कार्यालय वन संरक्षक, उत्तरी कुमाऊँ वृत्त, उत्तराखण्ड, अल्मोड़ा।

विषय :- पालड़ीछीना मल्लीढाना नैनी मोटर मार्ग निर्माण (प्रस्ताव सं० 11032/2015)।

विषय:- एस0सी0पी0 के अन्तर्गत जनपद बागेश्वर में पालड़ीछीना मल्लीढाना नैनी मोटर मार्ग प्रस्ताव संख्या (11032/2015।

परियोजना का नाम— जनपद बागेश्वर में पालड़ीछीना—मल्लीढाना—नैनी
मोटर मार्ग का निर्माण। लम्बाई 6.50 किमी०

Survey of India Toposheet (ALIGNMENT SHOWN ON MAP)

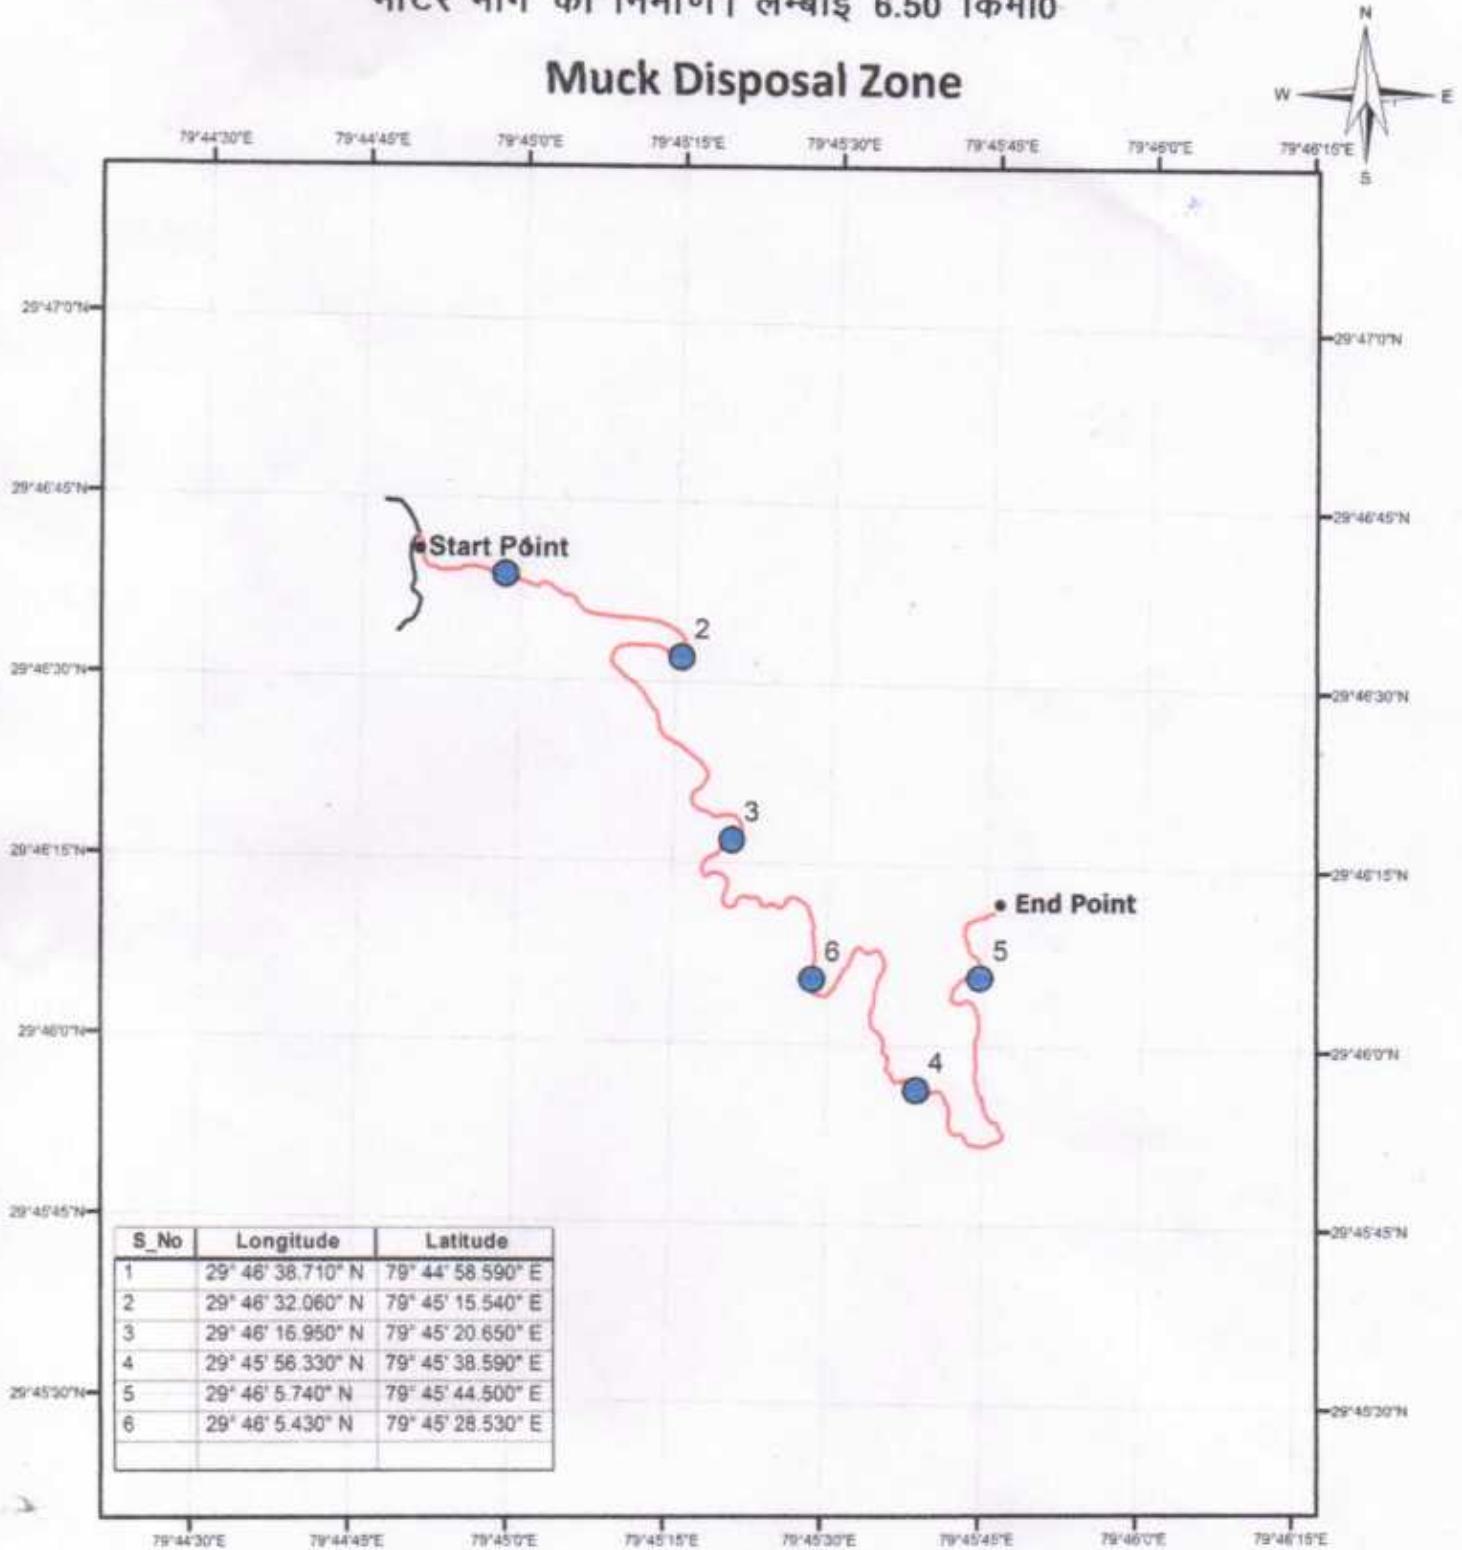
बिन्दु सं०	लगायी गयी आपत्तियों	आख्या
1	In the geo referenced digital Map of the area proposed for diversion uploaded at C(IV) Part I online, Geo coordinates are shown very few points May provided upload scanned copy of GIS software generated Geo-referenced digital Map to the exact scale of the proposed road showing Geo-coordinates at 200 to 300 m interval along the alignment including all turning points.	new fresh geo referenced Digital Map of the alignment showing coordinates 200 to 300m interval for proposed road has been uploaded as per direction.
2	As per KML file of the alignment of the proposed road uploaded at C(ii)b Part I online, the last stretch of the road including a very long U turn appears to be extending too much inside the forest where are no villages located. The Part of this long U turn can be shortened without leaving any habitation out thereby reducing the requirement of forest land and the number of trees to be	The last stretch of the road including a very long U turn appears is not for any habitation but it is for Jhiroli Magnesite Factory for which long U turn appears.

Disital Map (Compensatory Afforestation)

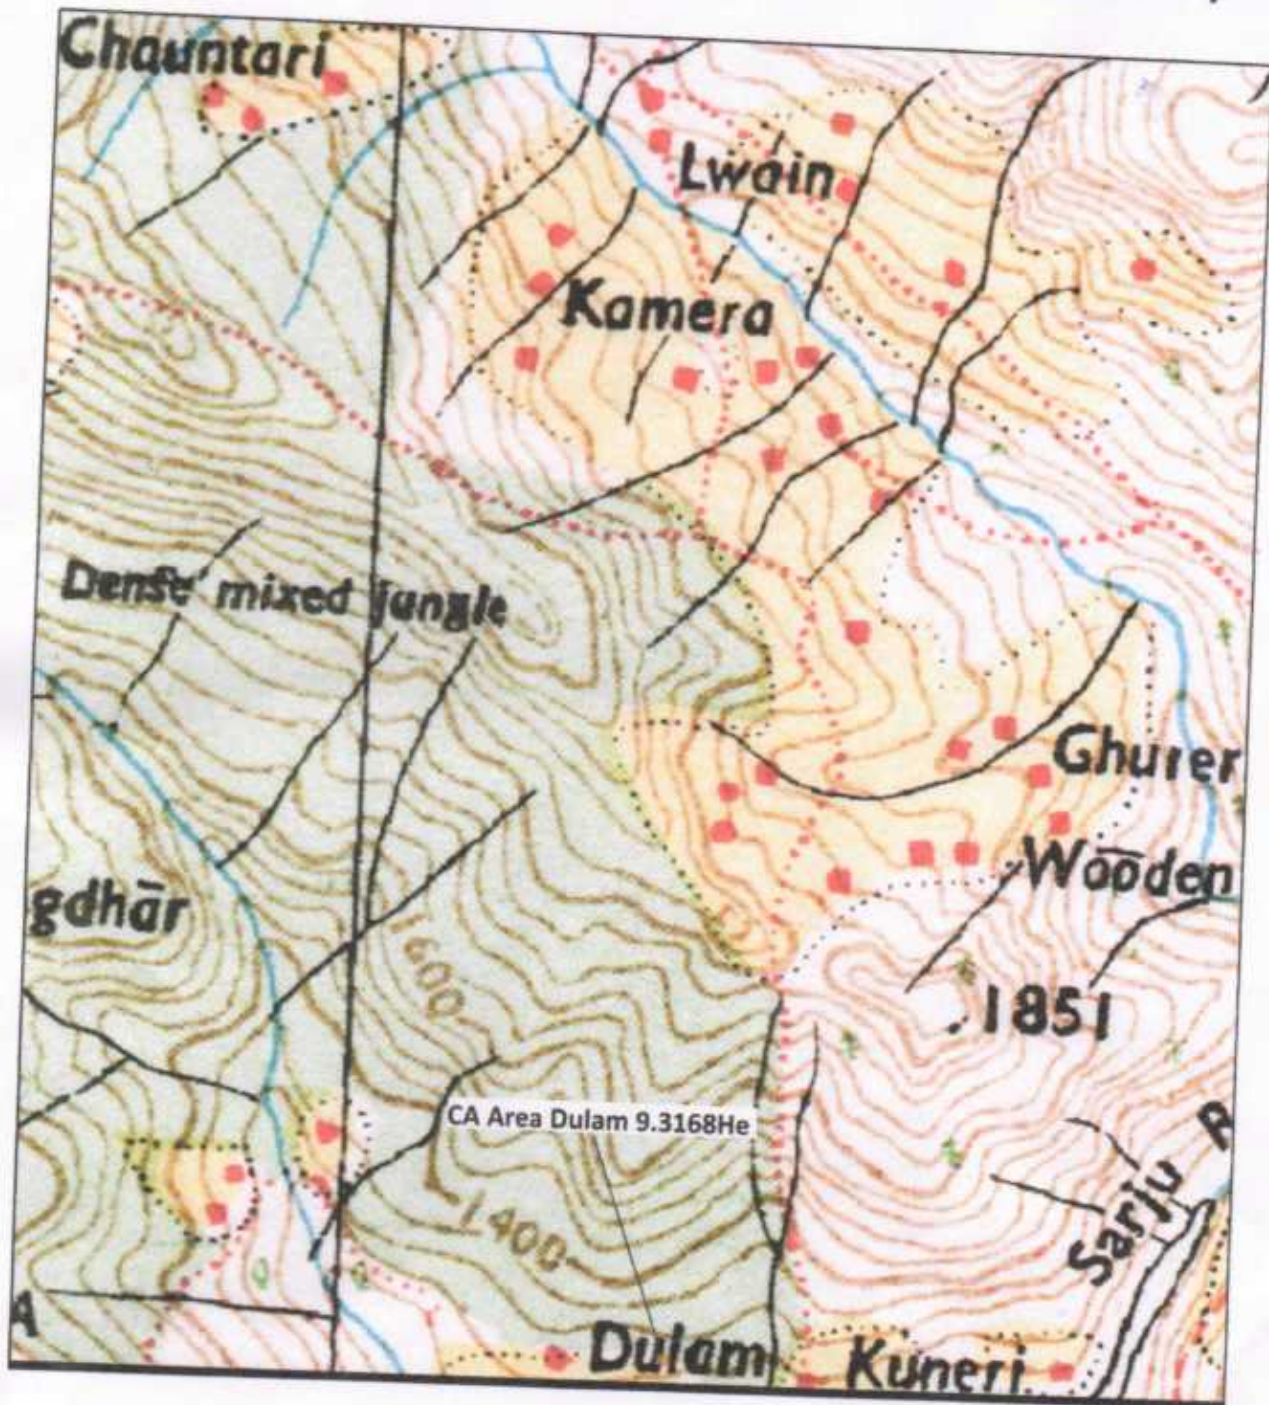
6	The digital Map of area proposed for CA uploaded at I(iv) Part I & 13 (ii) Part II online is different from each other further this Map is provided in Google earth image which does not serve any useful purpose. Geo-coordinates are provided for one point only and the Map is also not in shape file. May provide/upload GIS software generated geo-referenced digital Map of the area proposed for CA providing Geo-coordinates at all corners points in shape (polygon/closed area) file.	As per direction, New digital Map of area proposed for CA providing Geo-coordinates at all corners points in shape (polygon/closed area) file prepared & uploaded at I(iv) Part I.
7	Administrative approval and financial sanction for construction of this road uploaded as additional document in Part I is issued in the	Administrative approval and financial sanction for construction of this road uploaded as additional document in Part I which is issued in the year 2008-09 is valid
